**TRANSMITTAL**

**PROJECT:** OMFS #4

Orchard Mesa Fire Station No. 4  
2880 B 1/2 Road  
Grand Junction, Colorado 81505

City of Grand Junction  
Fire Department  
Redlands Fire Station No. 5  
Grand Junction, Colorado

E6

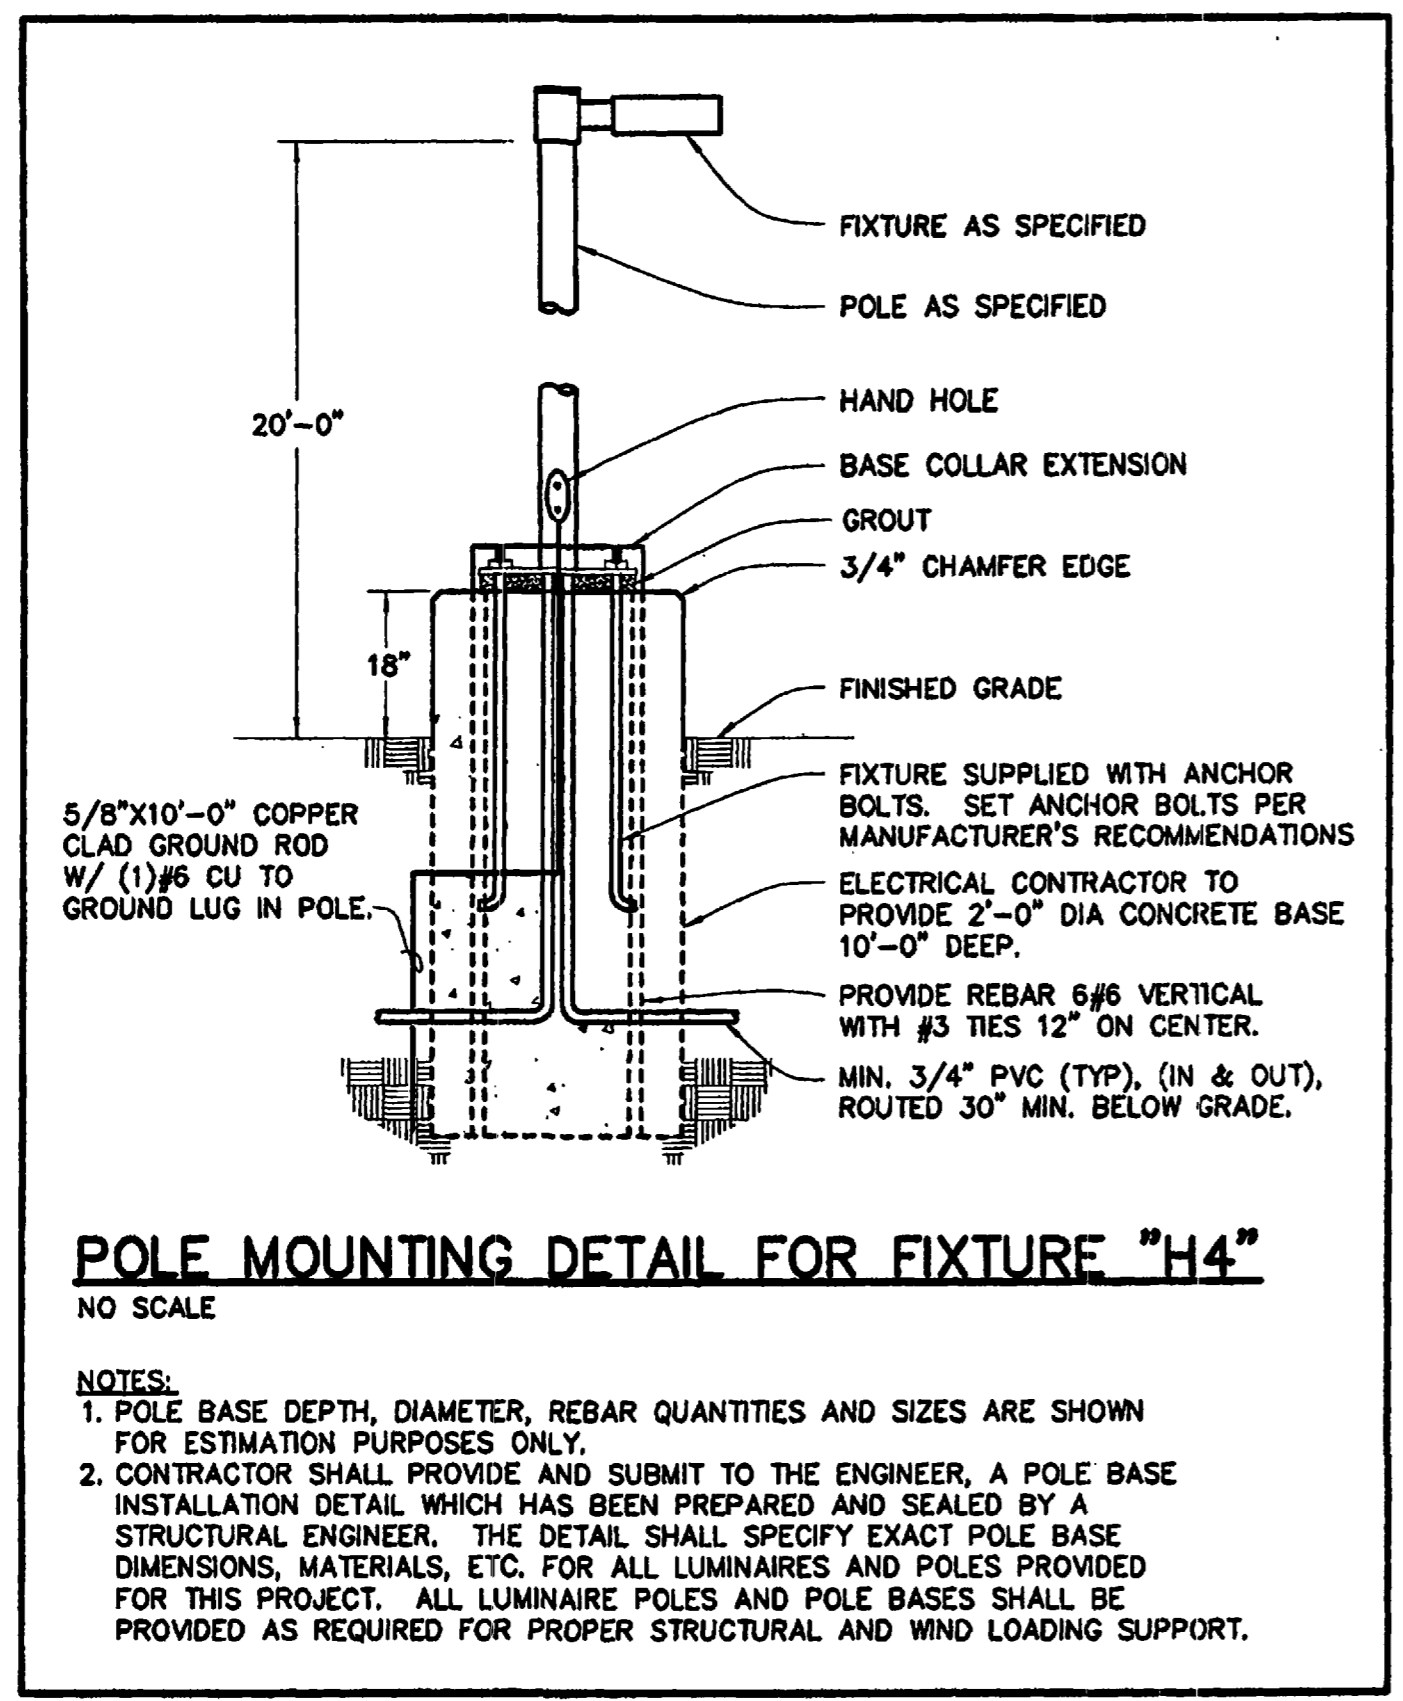
36. Sheet E6 - REPLACE:  
 1. Luminaire Schedule: Added lens to downlight type F3 and changed lamp; Deleted luminaire types F1 and F2; Changed type F4 to 3-lamps from 2; Revised type F13 to lowered industrial with wire guard; Added types F14, F15 and F16 fluorescent fixtures; Deleted type H1 metal halide high bay fixture; Changed type H2 and H4 fixtures to square shoebox and changed lighting source to high pressure sodium.  
 2. Special Equipment Schedule: Added load information on overhead door openers E-11; Added unit E-15; Portable air compressor, 20HP, 51A, 110V.  
 3. One Line Diagram: Added breaker and feeder for air compressor, downsized ATS, feeder breaker and generator breaker from 200A3P to 150A3P.

16. Sheet E6: REVISE:  
 a. Luminaire Schedule: Change number of lamps for fixture type F6 from 2 to 3.  
 b. Luminaire Schedule: Add "house-side Shield" option to pole mounted Luminaire Type H4.  
 c. One Line Diagram: Downsize circuit breaker sizes for Panels LB and LM in the MDP from 200A3P to 100A3P. Reduce the feeders for these panels from 200A to 100A, i.e. change (4#2+1#6)1-1/4"Ø to (3#2+1#4)1-1/4"Ø.
